**MERTHYR TYDFIL COUNTY BOROUGH COUNCIL
ROAD TRAFFIC REGULATION ACT 1984 – SECTION 23
PEDESTRIAN CROSSING**

Toucan Crossing Rocky Road

RE - Proposed toucan crossing on Rocky Road,
Penydarren, Merthyr Tydfil

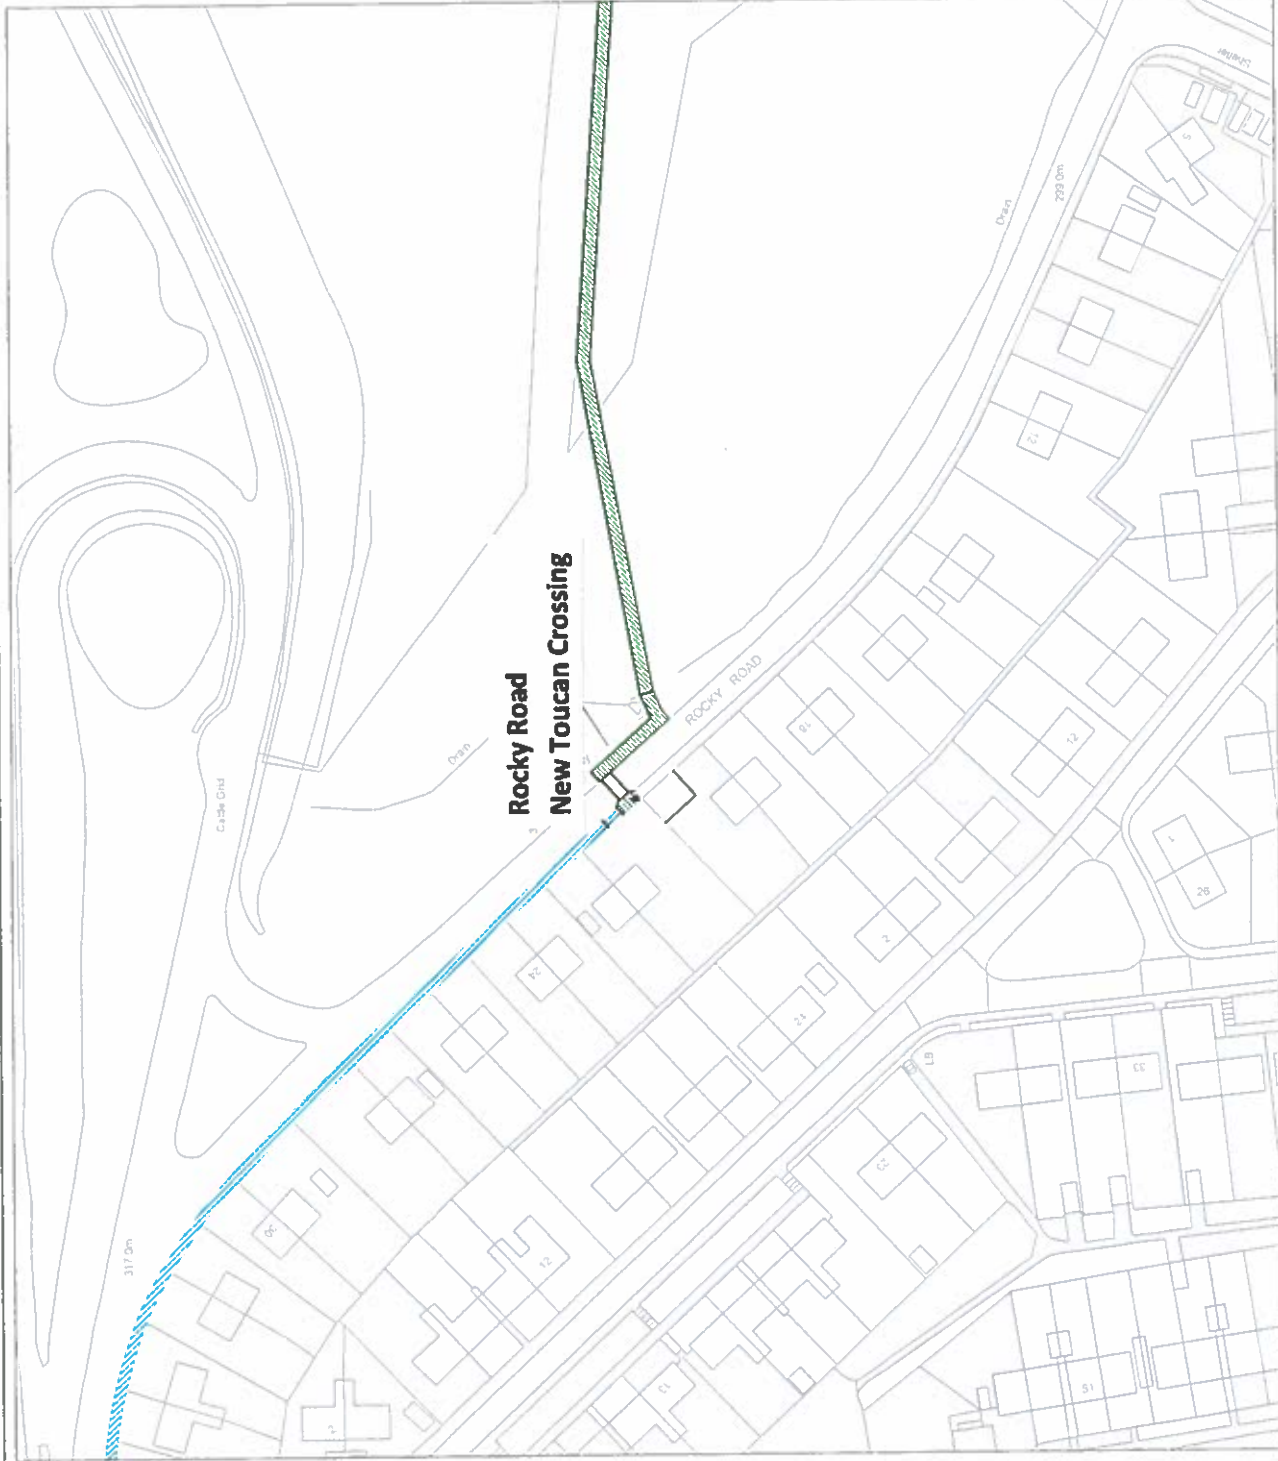
Merthyr Tydfil County Borough Council are intending on inputting a toucan crossing on the Rocky Road, Penydarren as it is believed that this is required in order for pedestrians and cyclists to cross over easily. The position of the crossing as we understand is to be approximately half way down the Rocky Road, between numbers 20 and 21.

Where the crossing is to be placed will make it extremely difficult for residents to park their cars, particularly those at numbers 20 and 21. In accordance with Rule 191 of the Highway Code "you must not park on a crossing or in the area covered by the zig-zag lines" For the residents who have paid to input a driveway the placement of the crossing makes it extremely difficult to park their vehicles given it is illegal to manoeuvre on/over a crossing, this has not been considered at all and the Council seem to have given this no thought. The location of the crossing is to be directly outside a driveway, the residents and owners of the driveway have paid for the advantage of having a drive and dropping the curbs, it is therefore their right to park the vehicles in or in front of the drive should they so wish, how is this going to be safe if the crossing is outside their house? It also makes it extremely difficult should friends or family visit and park their cars outside of the drive or on the road as this will cause congestion.

For those residents who do not have a driveway and have to park their cars on the road, the crossing will in fact be more unsafe than safe as it will cause a build up of traffic and congestion and is placing their cars at an increased risk of damage.

In addition to the above reasons the noise of the crossing is going to be an inconvenience to the residents and there is potential for the crossing to become a magnet for vandals and youths which will cause a depreciation in house values and prices in the area. No other toucan crossings seem to be placed directly outside of residences and consideration should be given to the fact that no school children use the path opposite numbers 20/21 of the Rocky Road which lead to the 'Ivor' as the path is far too dark and unsafe. There is no lighting in situ and is often frequented by intoxicated men/youths and large dogs that are not on a lead.

It is argued that the toucan crossing is not in demand and will not make crossing the Rocky Road any safer and there is more demand for the crossing to be placed on the Galon Ucaf cross roads or at the top of the Rocky Road where there are no properties it would directly affect and crossing is far more hazardous.
